Public Comments

Subject: 80 Clear Creek Road Viewshed Protection Program P22-00182-VIEW, Initial Study/Mitigated Negative Declaration, SCH No. 2025091008, Napa County

Re: 80 Clear Creek Road, Napa, Viewshed Protection Program Application P22-00182-VIEW (the "Application")

B. TENNIS COURT & PAVILION VIEW AS VIEWED FROM THE SILVERADO TRAIL

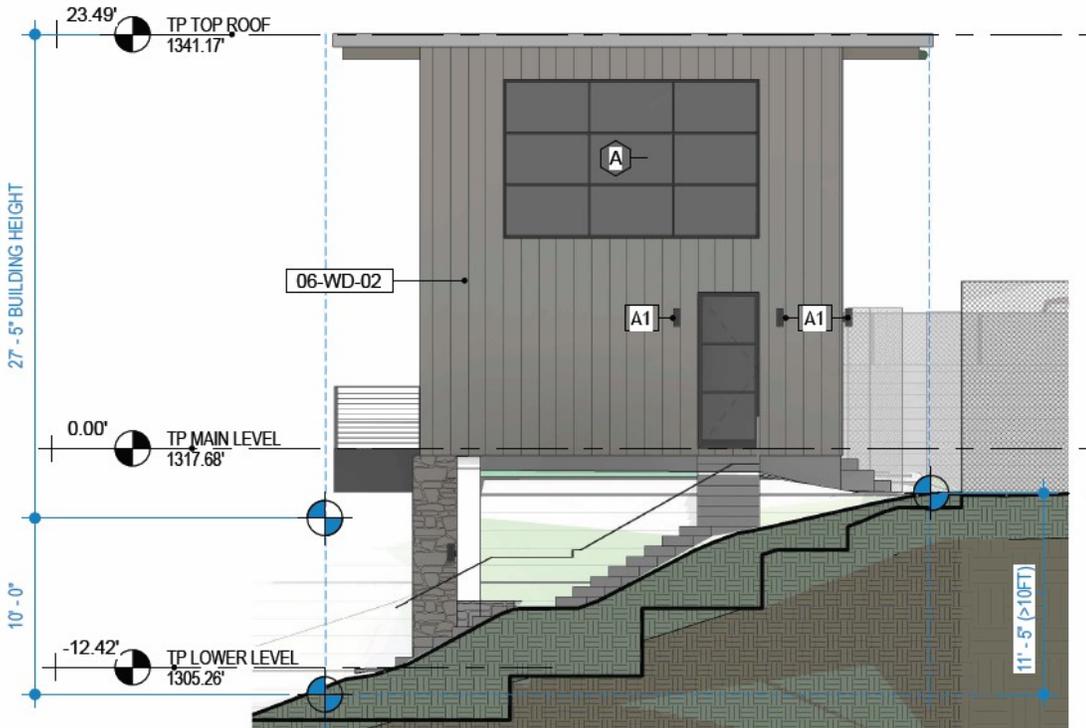
As seen in the images following this letter (excerpted from the Application), the proposed project falls short on many of the design requirements set forth in the Viewshed Protection Design Manual, particularly section 2 (design, height and massing of hillside development). The tennis pavilion is a massive three-story rectangle – it is 82' x 34' and approximately 37' feet tall from lowest grade (possibly exceeding the maximum 35' height (see Napa County Code 18.104.010 table of zoning district regulations) – it contains 6,240 square feet (2/3 the amount of space in the main residence) – the face is covered with a significant amount of glass and metal, and the roof line is lighted, both of which will enhance its negative visual impact.

Here are just a few of the tennis pavilion's departures from the design principles intended to protect the natural beauty of the Valley:

- No balance of scale and proportion
- Design elements are not harmonious with natural landforms (there are no giant rectangle boxes in nature)
- Not small scale or low in height
- Does not conform to hillside topography by stepping or staggering mass up or down the slope
- Predominate feature is flat vertical massing with a lighted roofline
- No articulation to break up the scale and mass of the building
- Protrudes above ridgeline, highly visible from surrounding roads, including major public roads
- Does not minimize lighting, maximizes it for convenience of tennis players
- Height may exceed 35' maximum
- Uses vertical massing and stacking instead of integrating the structure with the slope
- Roof not sloped, diverges sharply from natural slope, does not follow the gradient

Additionally, screening of the tennis pavilion is highly inadequate (see graphics A004-00, A005-00, landscape site plan LA1 and LA2). The viewshed vegetative screening letter proposes 10-gallon replacement trees, which are young saplings 4-6 feet tall. For these to reach a mature height of 50 feet will take 30 to 50 years (according to ChatGPT). Effectively, there will be no screening for decades at best.
